Access Compliance Report

Public Rights-of-Way

(Curb Ramps)

Intersection ID: 3032	Main Street: FOX_GLEN_RD	Cross Street: FOX_HILL_DR	Location: S
ADA ID: B8BC789FDE6E	Ramp Type: Perp	Initial Pass/Fail: Fail	Overall Compliance: No
Severity Score: 1.25			
Codes/Mitigation Info/Possible Solution		Field Measurements/Component Compliance

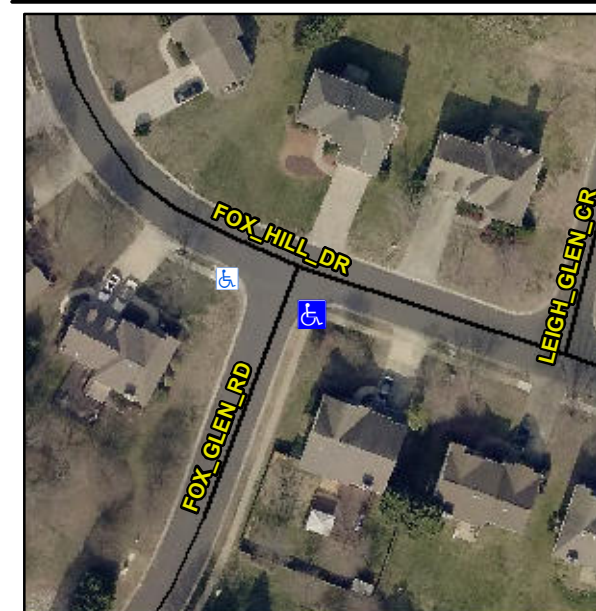
Not Found, R304.5.3

Compliance	Description	Data	Compliance	Description	Data
N/A	Ramp Length (in)	62.0	Yes	Ramp Slope (%)	6.9
Yes	Ramp Width (in)	48.0	No	Ramp XSlope (%)	3.6
N/A	Flare Type LT	N/A	N/A	Flare Type RT	N/A
N/A	Flare Slope LT (%)	N/A	N/A	Flare Slope RT (%)	N/A
N/A	Flare Traversable LT?	N/A	N/A	Flare Traversable RT?	N/A
N/A	Landing Length (in)	N/A	N/A	DWS Provided?	N/A
N/A	Landing Width (in)	N/A	N/A	DWS Contrast?	N/A
N/A	Landing Slope (%)	N/A	N/A	DWS Length (in)	N/A
N/A	Landing X Slope (%)	N/A	N/A	DWS Full Width?	N/A
N/A	Landing Curb? (Y/N)	N/A	N/A	DWS Offset (in)	N/A
N/A	Shared Landing?	N/A			
N/A	Gutter Ponding?	N/A	N/A	Gutter Slope (%)	N/A
N/A	Gutter Lip Ht (in)	N/A	N/A	Gutter X Slope (%)	N/A
N/A	Painted X Walk1?	No	N/A	Painted X Walk2?	N/A
	X Walk 1 Direction	To NW		X Walk 2 Direction	N/A
N/A	X Walk 1 Width (in)	N/A	N/A	X Walk 2 Width (in)	N/A
	X Walk 1 Slope (%)	5.4		X Walk 2 Slope (%)	N/A
	X Walk 1 X Slope (%)	2.4		X Walk 2 X Slope (%)	N/A

Remove & Replace Entire Ramp.
